Proposed Changes to *Receiver  
Device Physical Testing Section*  
in SAS 2 Draft Specification

Mike Jenkins  
11 March 2008

# Table 72 in Section 5.3.7.4.4.1

Figure 131 — Stressed receiver sensitivity test block diagram

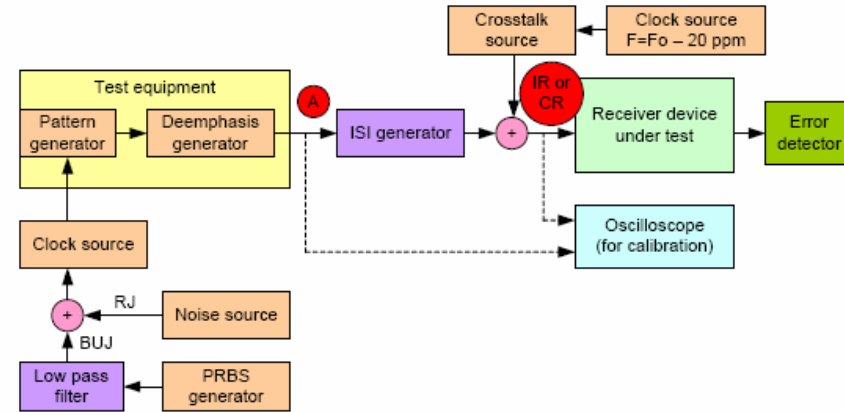
- More repeatable to measure to center of trace
  - Use vertical histogram
- For 800mVpp, 2dB launch, simulation yields  $Z1 = 101\text{mV}$

- Change Ref Tx (Table 65) & Tx peak-to-peak voltage (Table 72) to 850 mVpp
- Change Tx bounded uncorrelated jitter (Table 72) to 0.022 UI
- Change D24.3 delivered eye opening (Z1) (Table 72) to 100mV (min) & 115mV (max)
  - Measured at center of trace
  - Simulated value is 107mV for 850mVpp launch with 2 dB de-emphasis

# Tx Bounded Uncorrelated Jitter

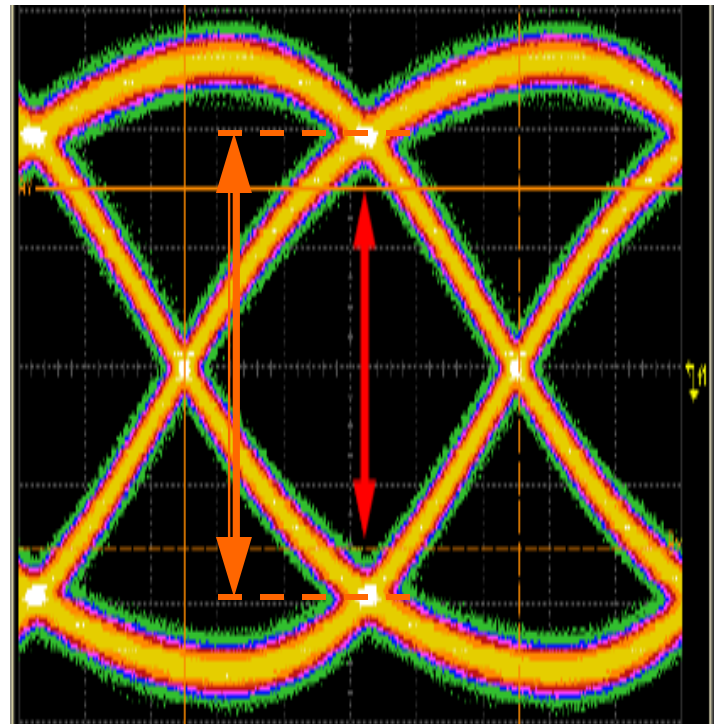
- Value in draft is impossibly small
  - 0.00022 UI is possibly the result of unintentional Excel percent formatting
- Value in 8G Fibre Channel is 0.035 UI (~20% of TX DJ budget)
- Propose 0.022 UI for 6G SAS
